# 2 Chester Square, London SW1

Non-material Amendment

Application References 20/02304/FULL

March 2021

### New slab profile to the uncovered under pavement vault

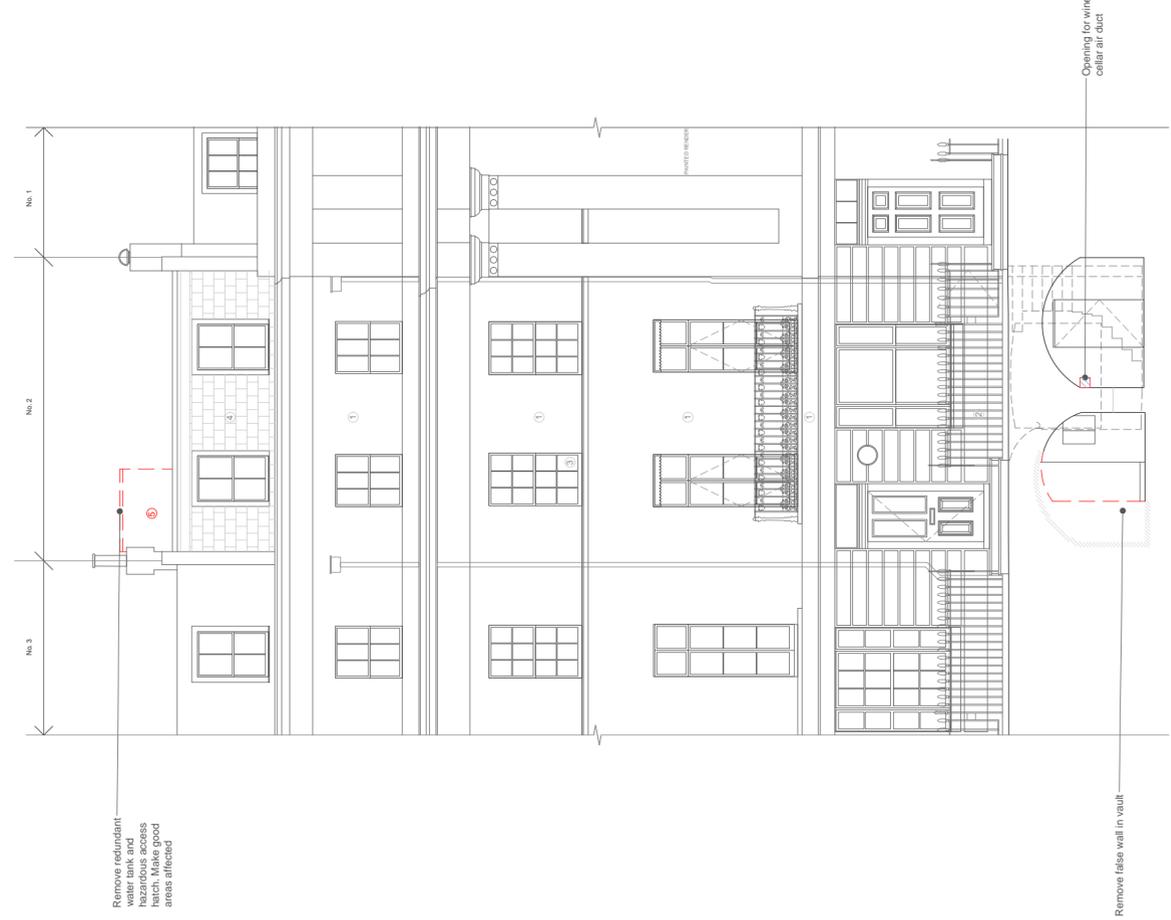
This report is a summary of the minor amendments that has altered the original proposed design in one internal area. The amendment is the profile of the new slab to the opened up under pavement vault at lower ground floor. Instead of a flat slab, we would like to recess the central portion to increase the headroom for ease of access.

As originally proposed and approved, the modern infill wall to the under pavement vault has been removed. We discovered a very damp vault beyond but the walls and ceiling are structurally sound. The floor however is a mix of dirt, a portion of concrete slab and some rubble. We would like to propose that the new slab to go in would have a recess in the centre to be able to stand up. We propose a recess in the centre so we do not disturb the existing foundations of the vault. We would also cast 3 steps to go down into the recessed part.

Please refer to drawings 1901-P12-099, 1901-P12-201, 1901-P12-300, 1901-P-099, 1901-P-201 and 1901-P-300 for more information.

Project: 2 Chester Square  
 Annie Blunden  
 Drawing Title: Front Elevation  
 Demolitions: 1:100 @ A3  
 1:50 @ A1  
 Drawing Number: 1801-PZ-300  
 Revision: E  
 Revision Date: 21/03/22  
 Project No: 1901  
 Y1 AM DD

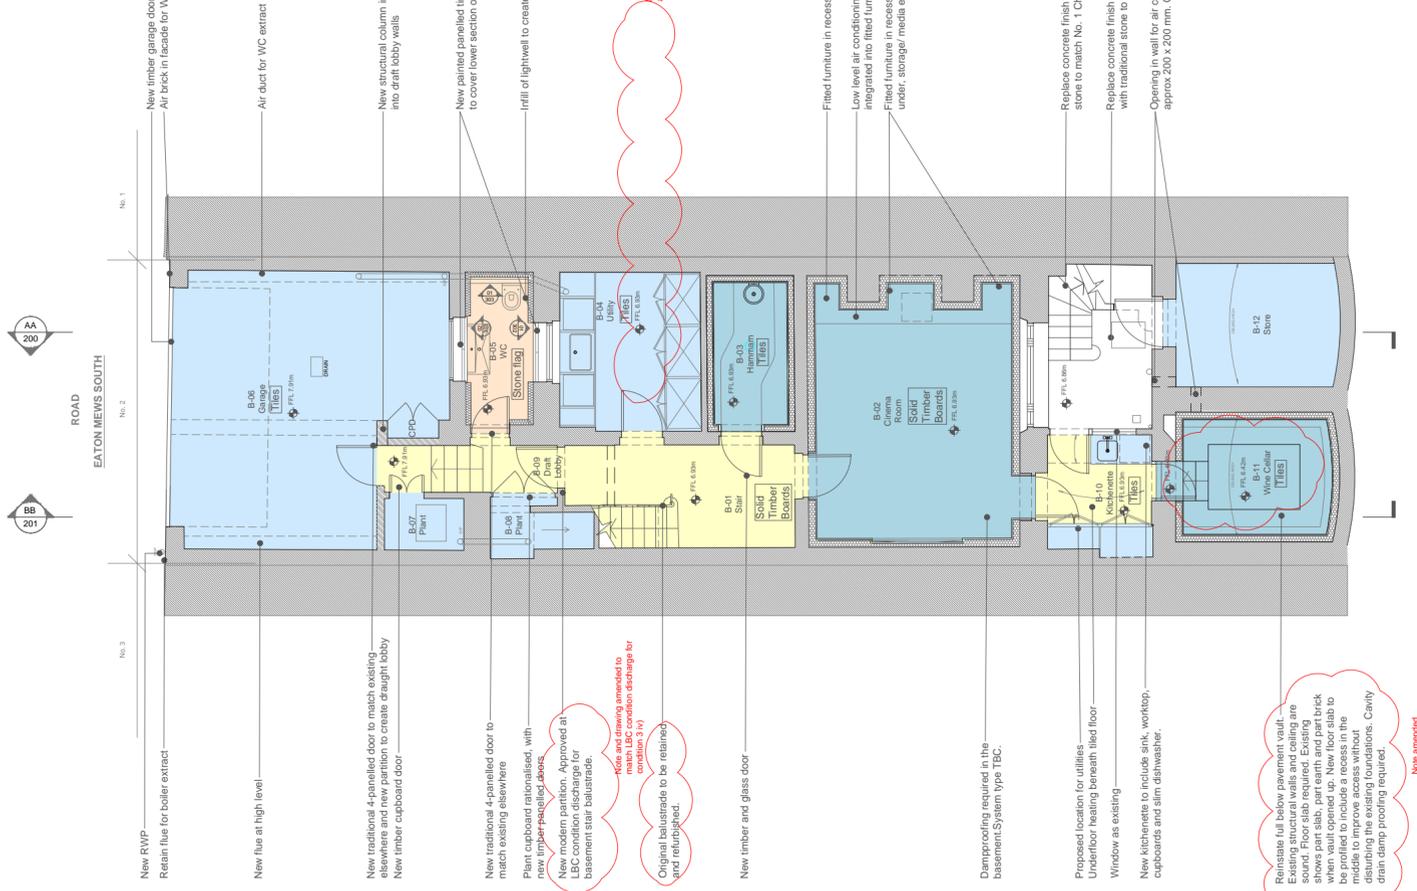
<p>Remove redundant hazardous access hatch. Make good areas affected</p> <p>Remove false wall in vault</p> <p>Create recess for new slab</p> <p><b>Now added</b></p>	<p>Remove opening for wine cellar air duct</p>
--	--

— Existing vault after the removal of the infill wall. The partial existing concrete slab is visible in the foreground

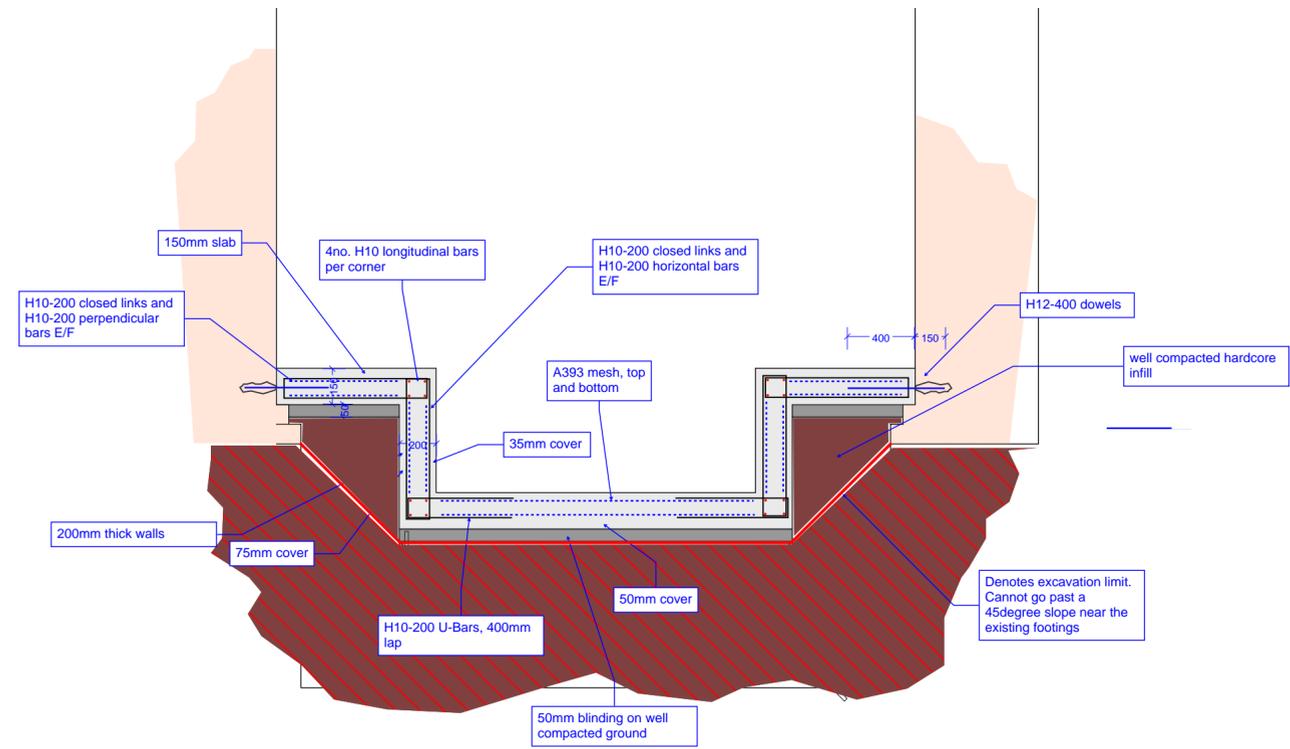
The existing vault beyond the wall infill is very damp but structurally sound. The existing concrete slab only covers part of the vault floor with the rest being hardcore. The proposal for the slab profile would not affect the foundations and the vault will be damp proofed with a cavity drain membrane. The lining to the vault will follow the wall and roof form.

- 01. Partial concrete slab which was visible on the house side of the removed infill wall
- 02. Rest of the vault floor is hardcore and earth
